**10 CFR 50.54(g)(5) Procedure Change Summary Analysis**

The following Exelon Generation Company, LLC (EGC) Emergency Plan documents have been revised and/or implemented for the Clinton Power Station, Unit 1 (Clinton):

- EP-AA-1003, Revision 27, "*Radiological Emergency Plan Annex for Clinton Station*"
- EP-AA-1000, Revision 28, "*Exelon Nuclear Standardized Radiological Emergency Plan*" (reinstated)
- EP-CL-1000, Revision 0, "*Clinton Emergency Plan*" (superseded)

EP-AA-1003, Revision 27, "*Radiological Emergency Plan Annex for Clinton Station*"

Figure 4-1: Onsite Assembly Areas

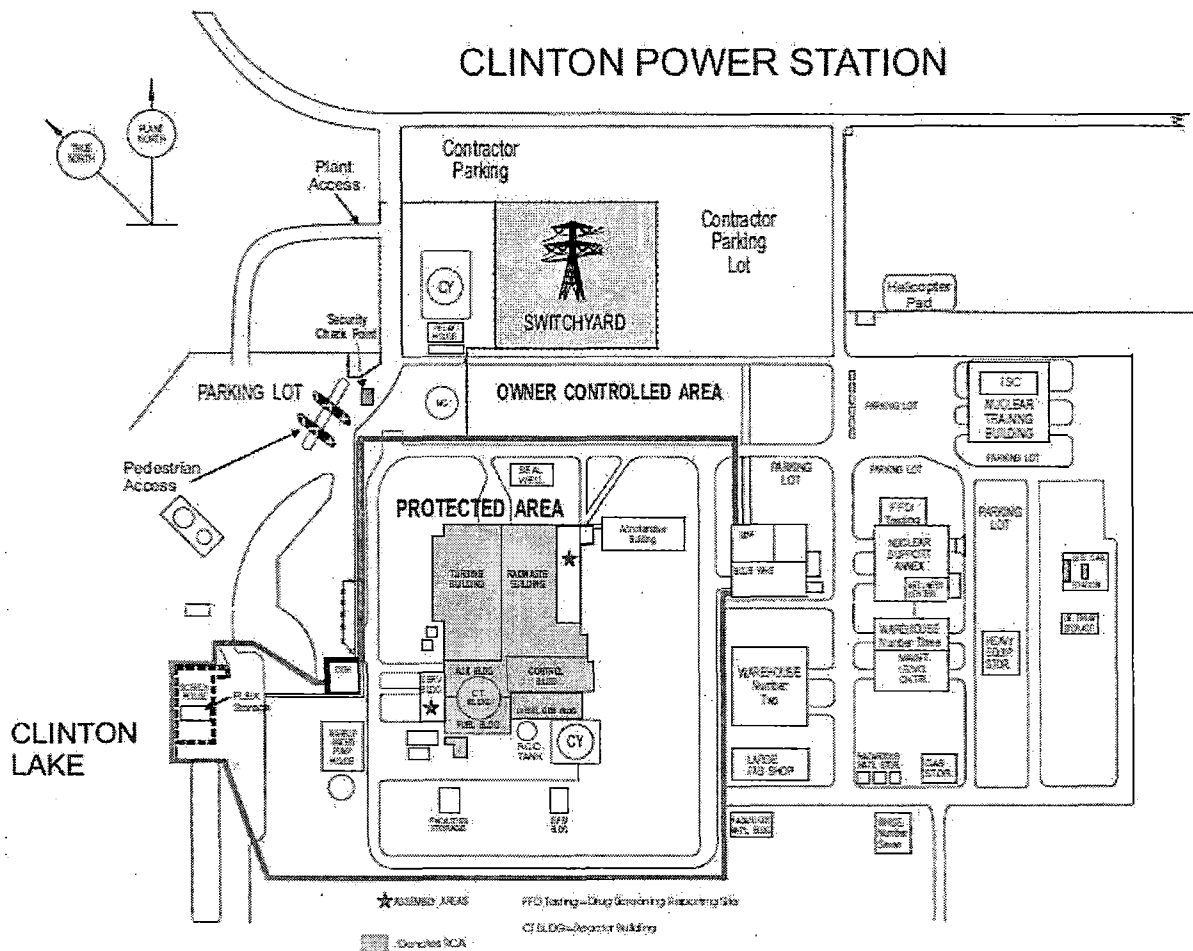
The Clinton Emergency Plan Annex was revised to update Figure 4-1, "Onsite Assembly Areas," to represent the site building configuration post Independent Spent Fuel Storage Installation (ISFSI) and improve the detail of the figure.
